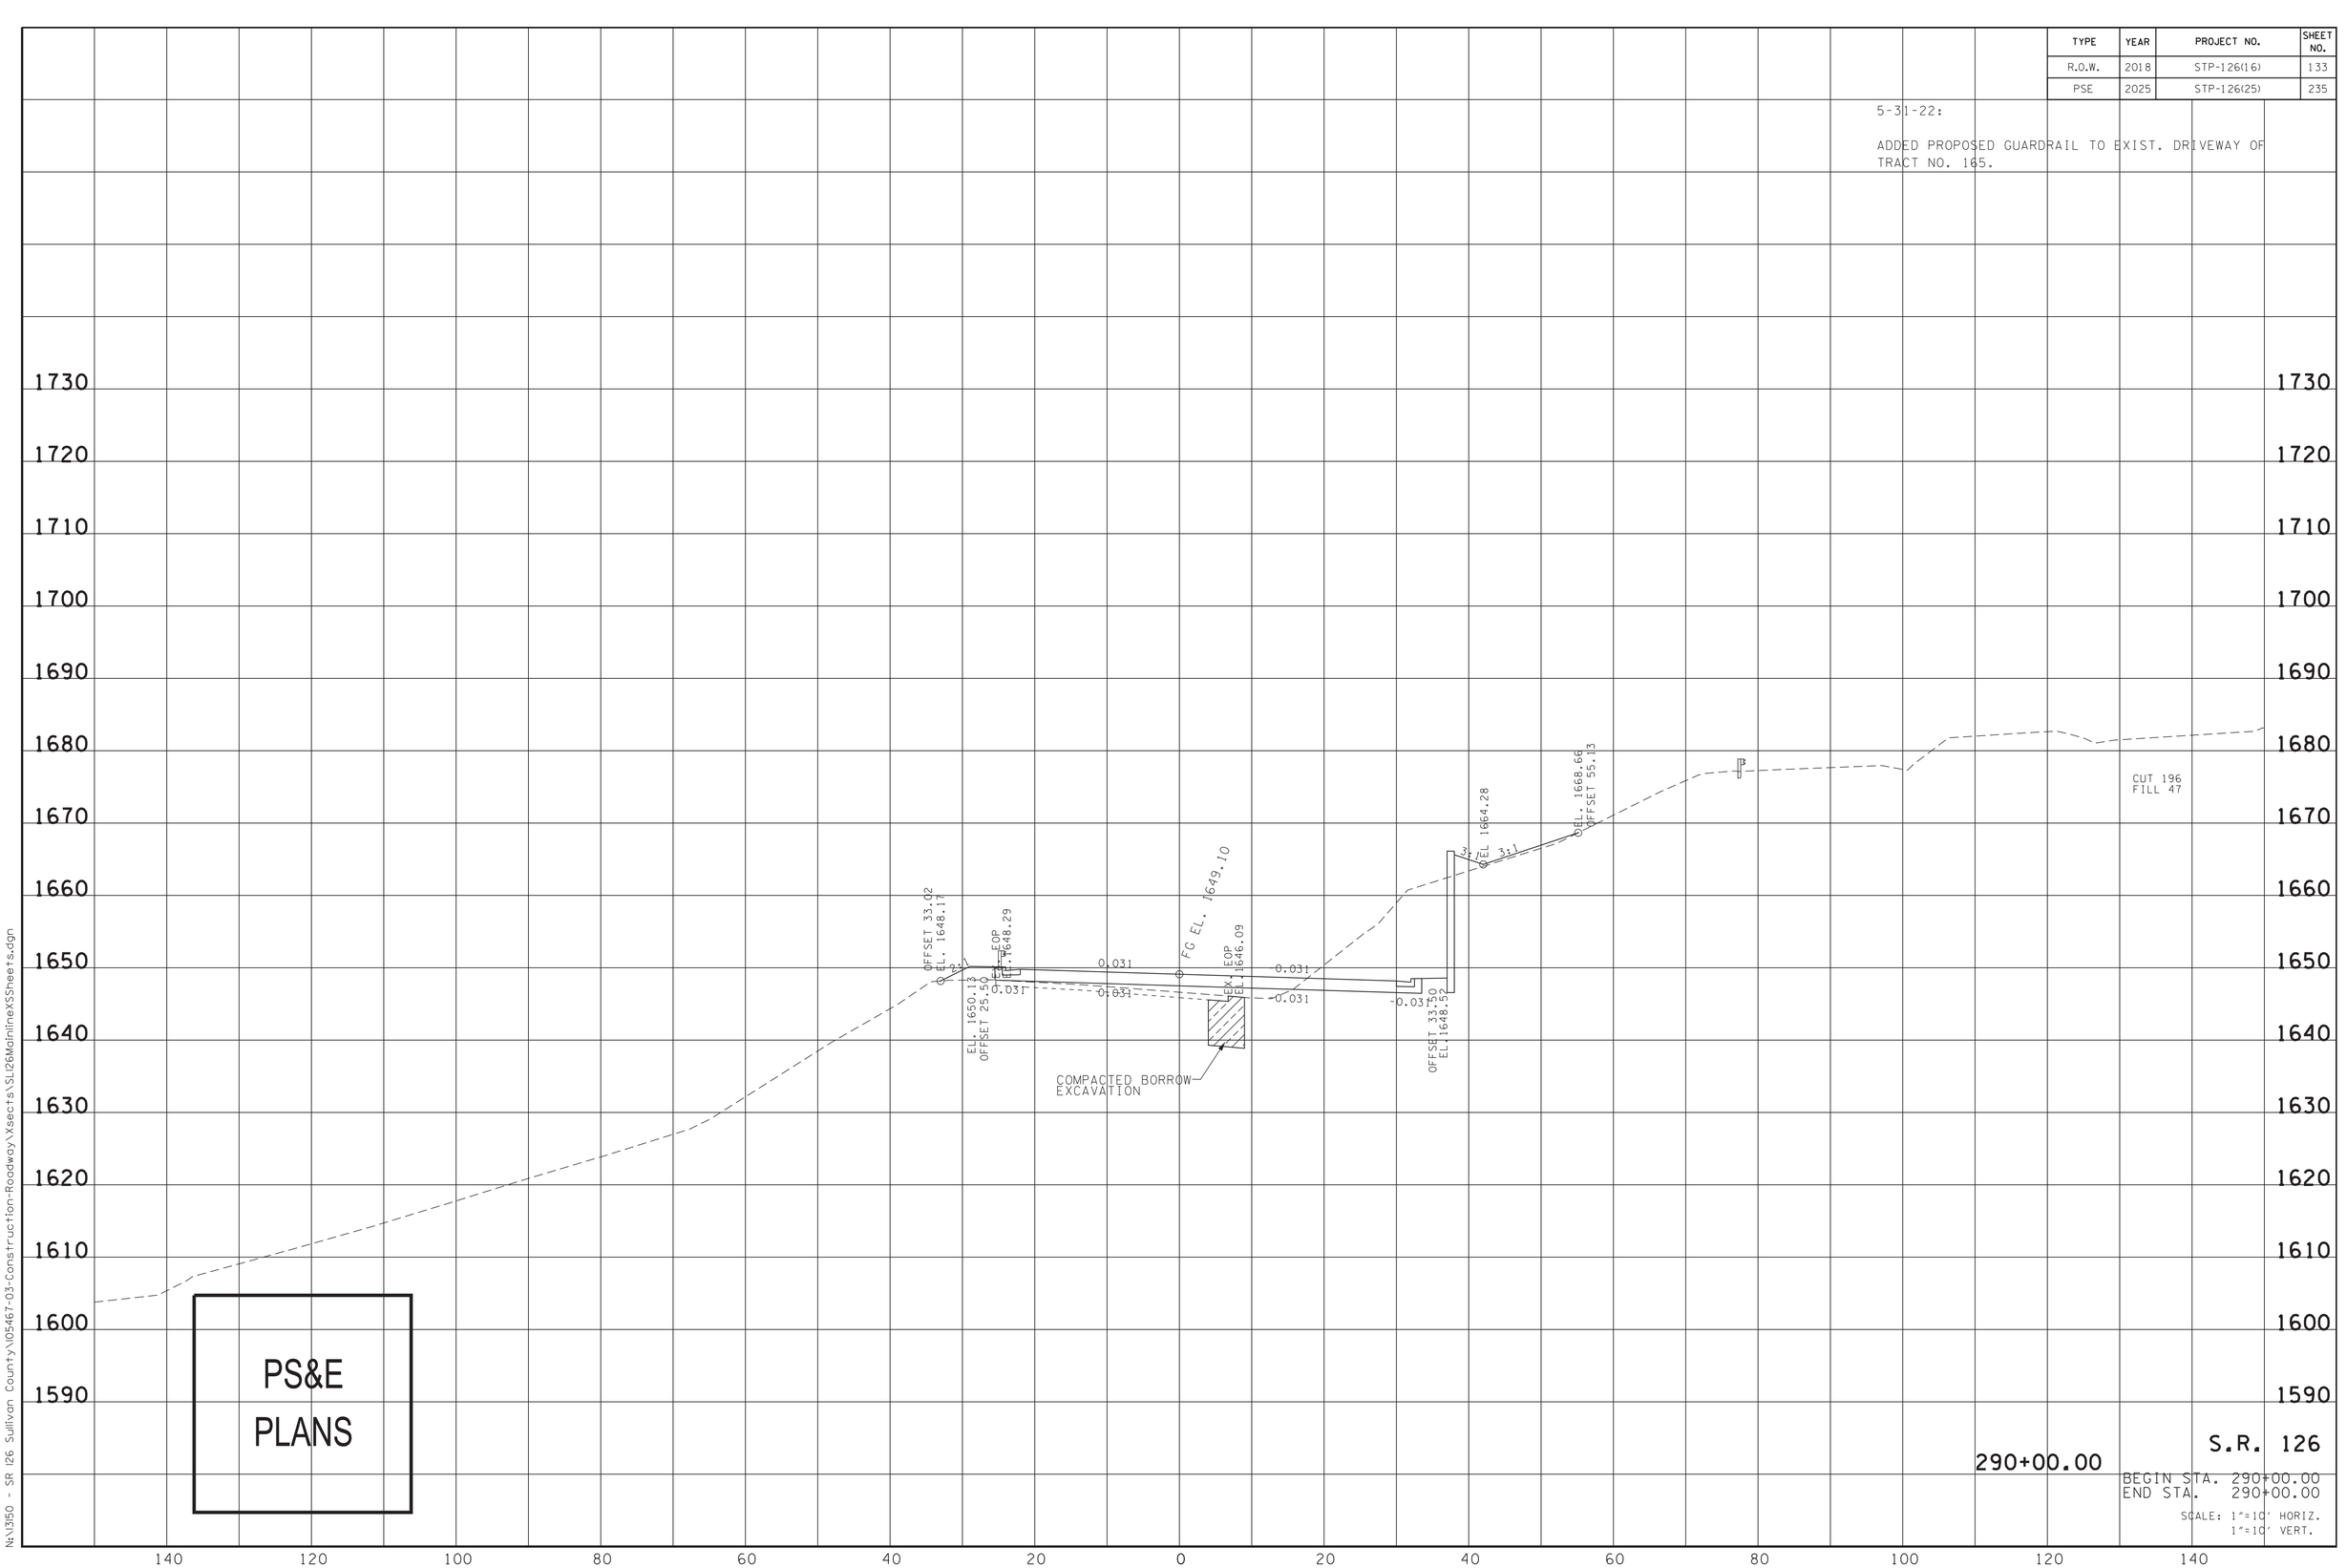
ADDED PROPOSED GUARDRAIL TO EXIST. DRIVEWAY OF TRACT NO. 165.

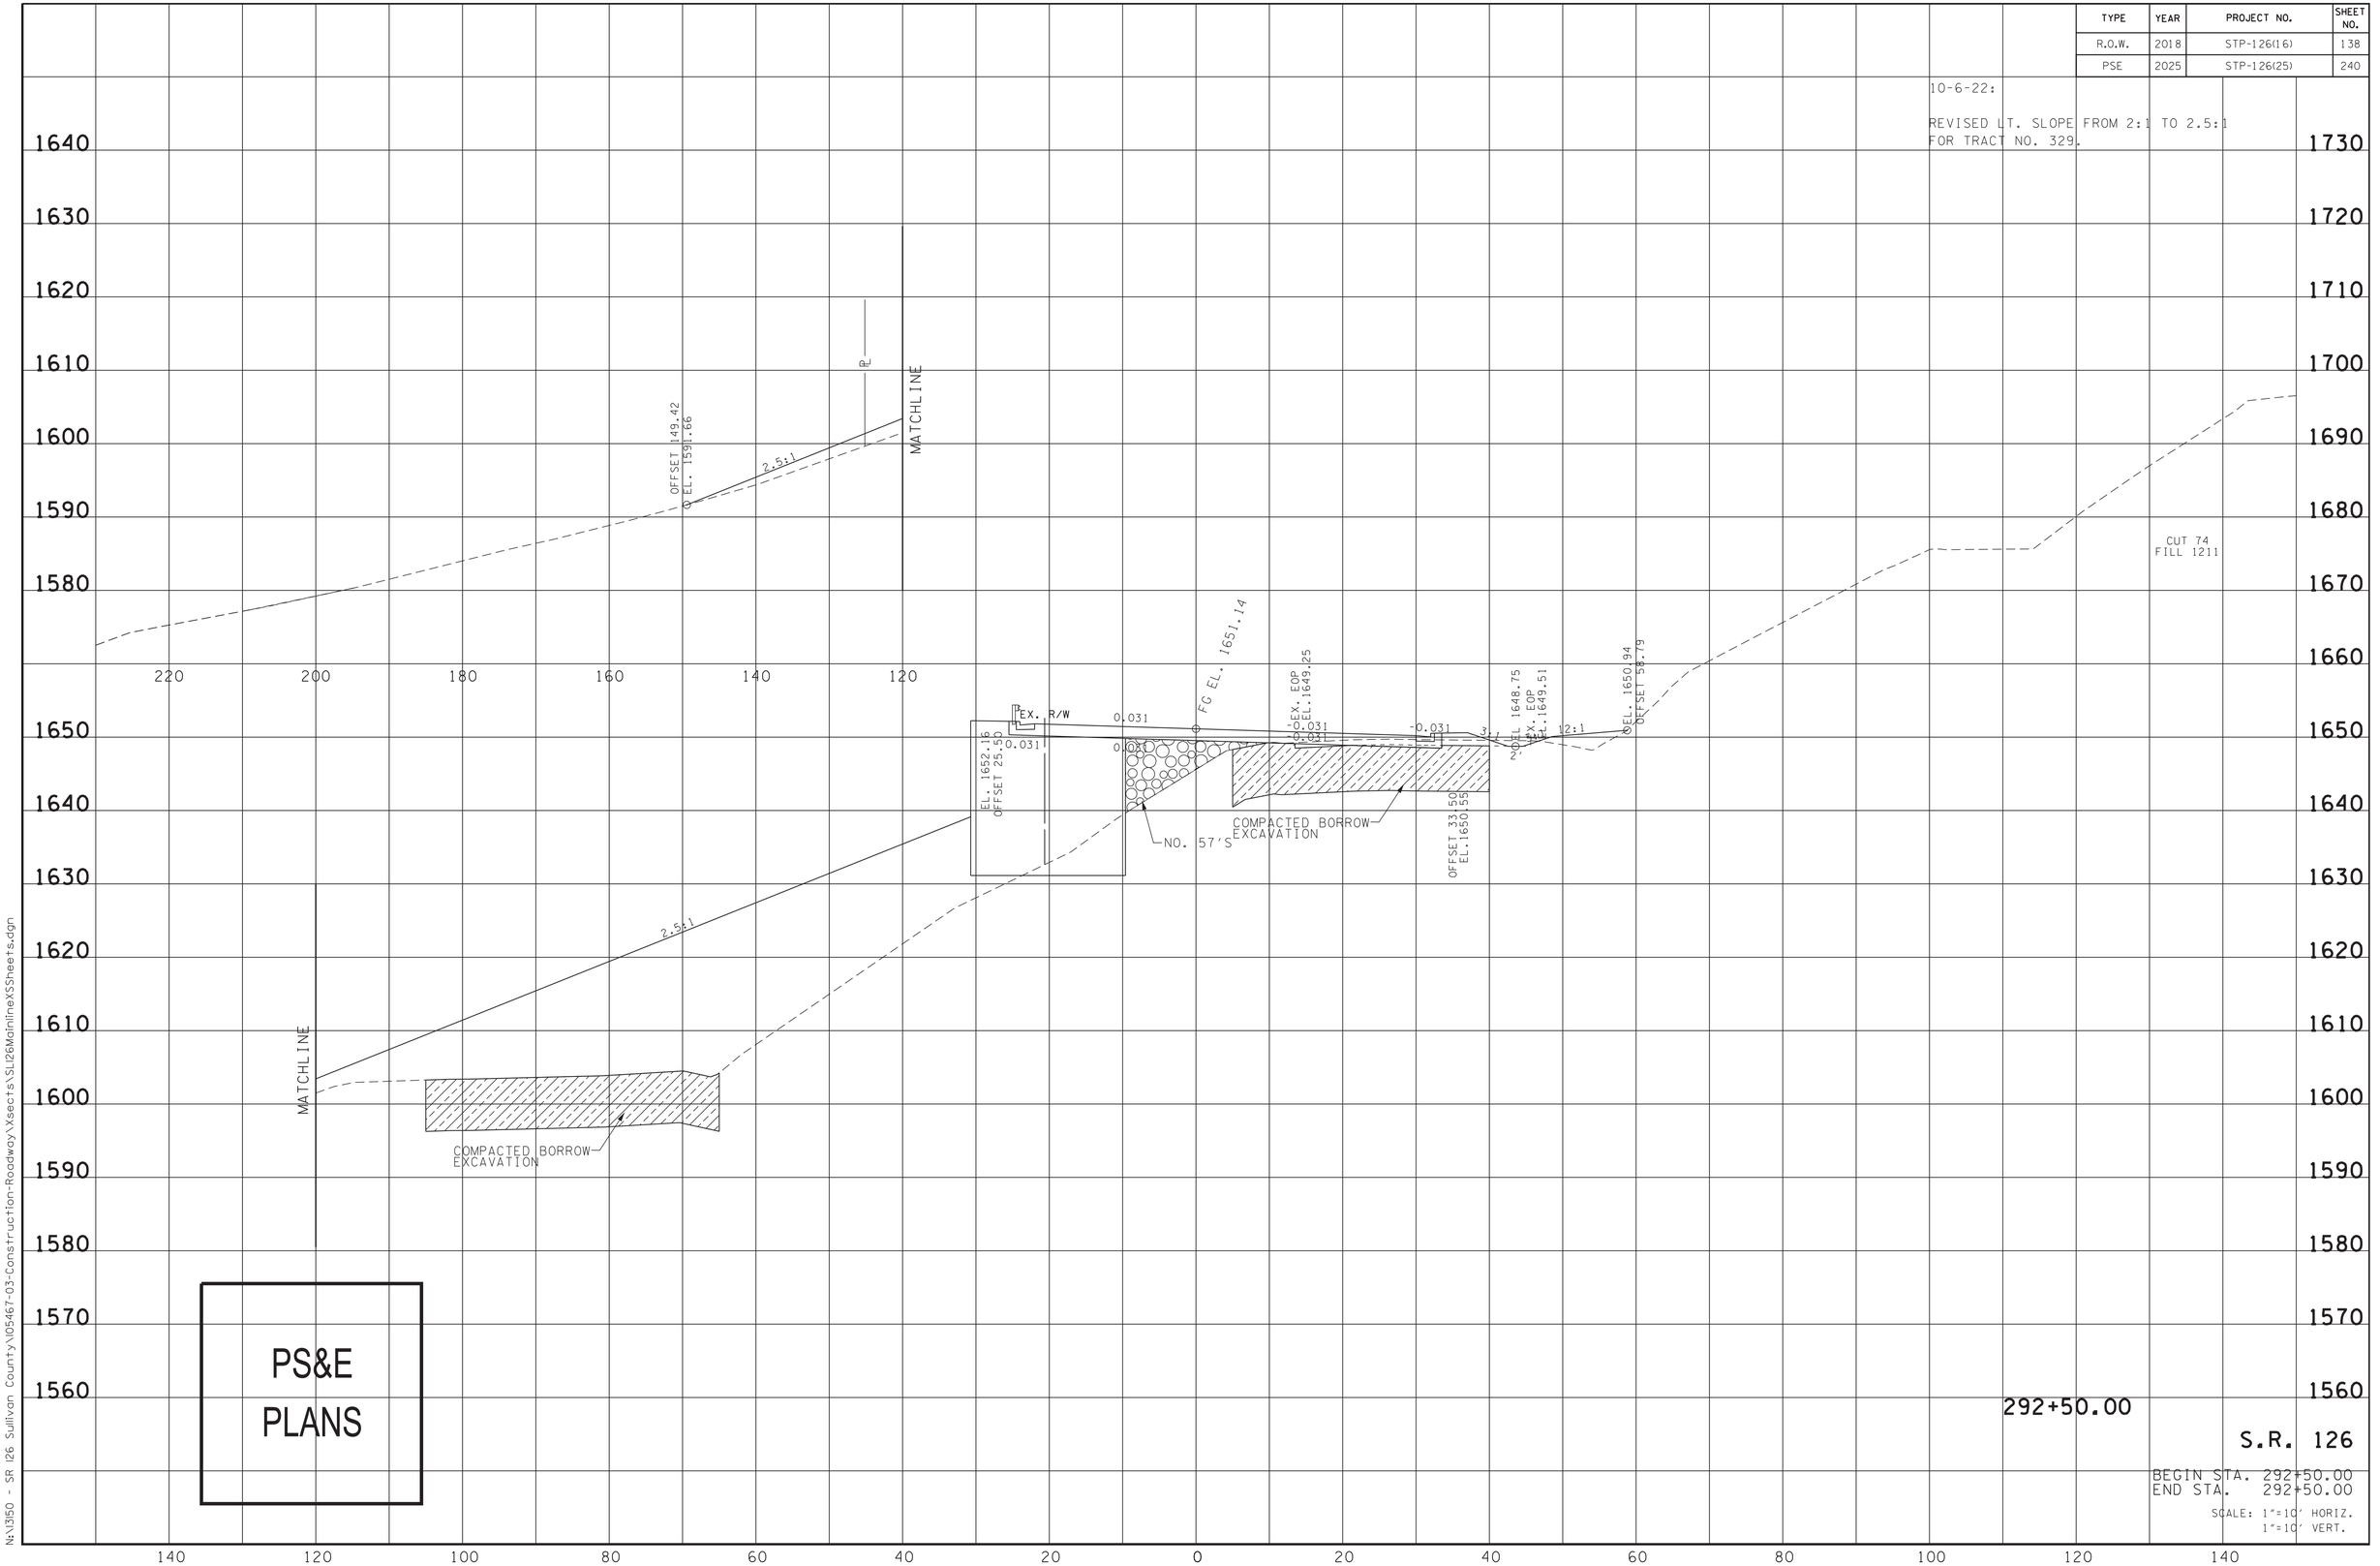
REVISED LT. SLOPE FROM 2:1 TO 2.5:1
FOR TRACT NO. 329.

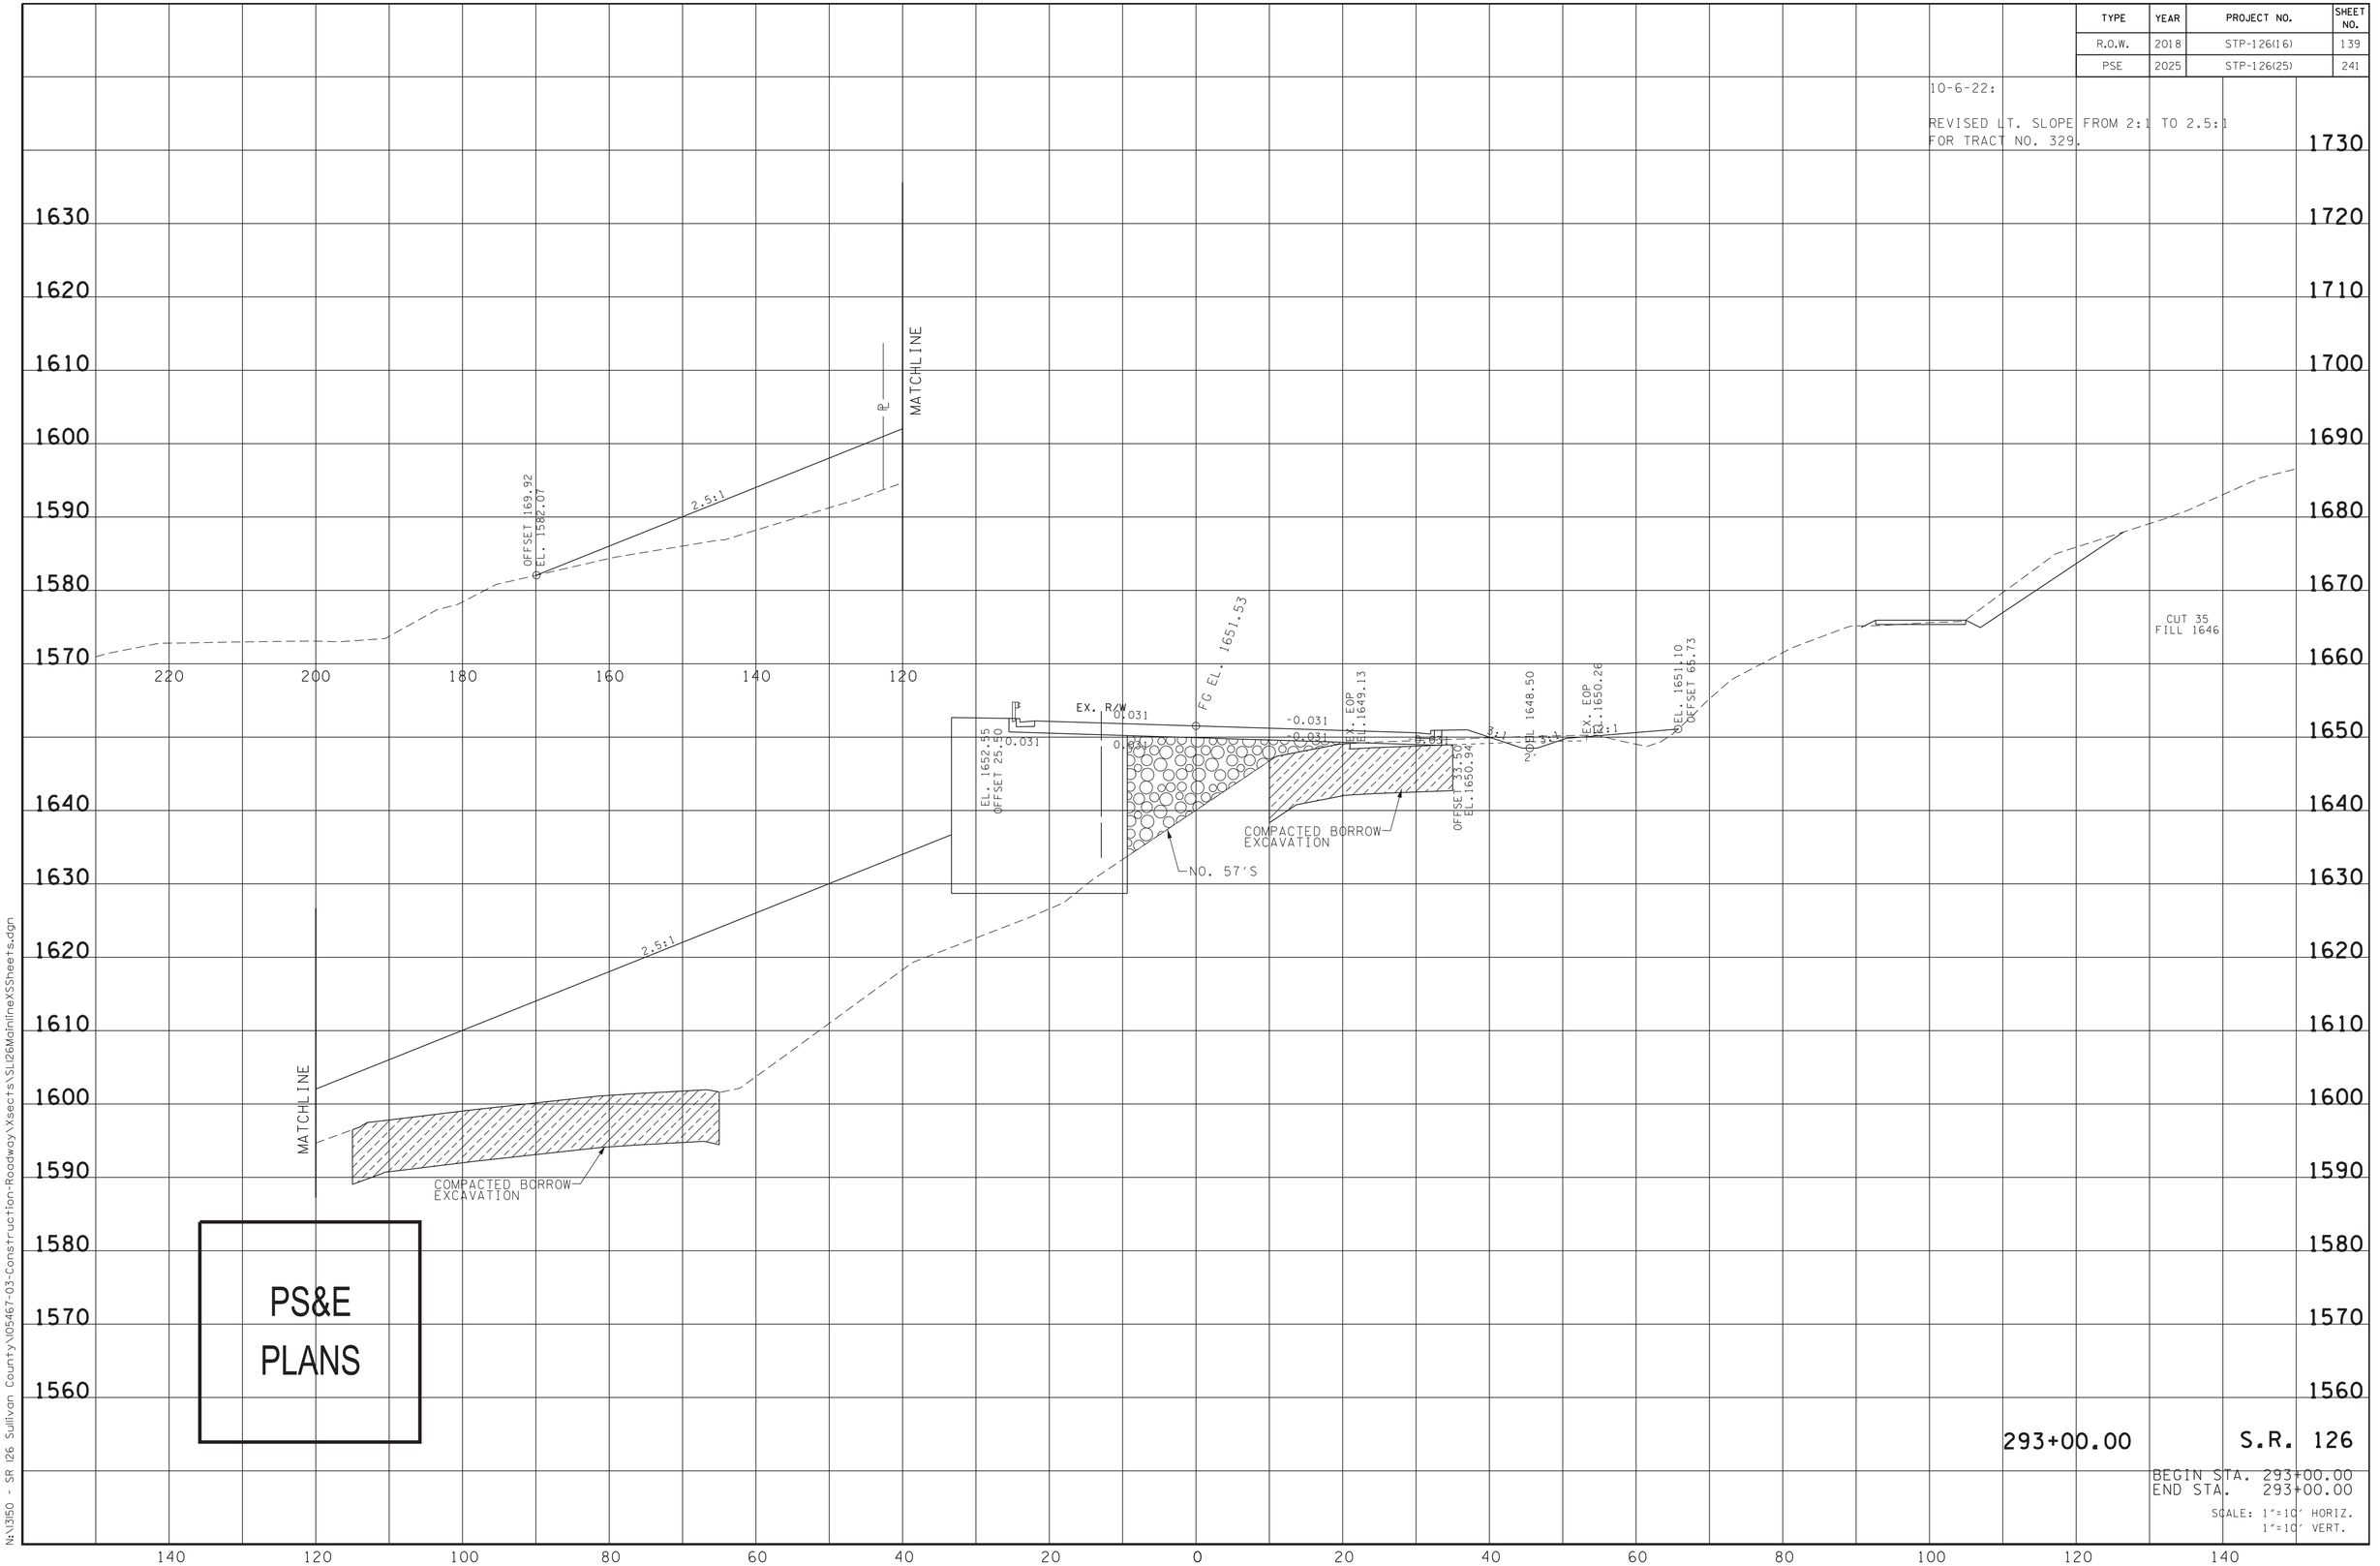
REVISED LT. SLOPE FROM 2:1 TO 2.5:1
FOR TRACT NO. 329.
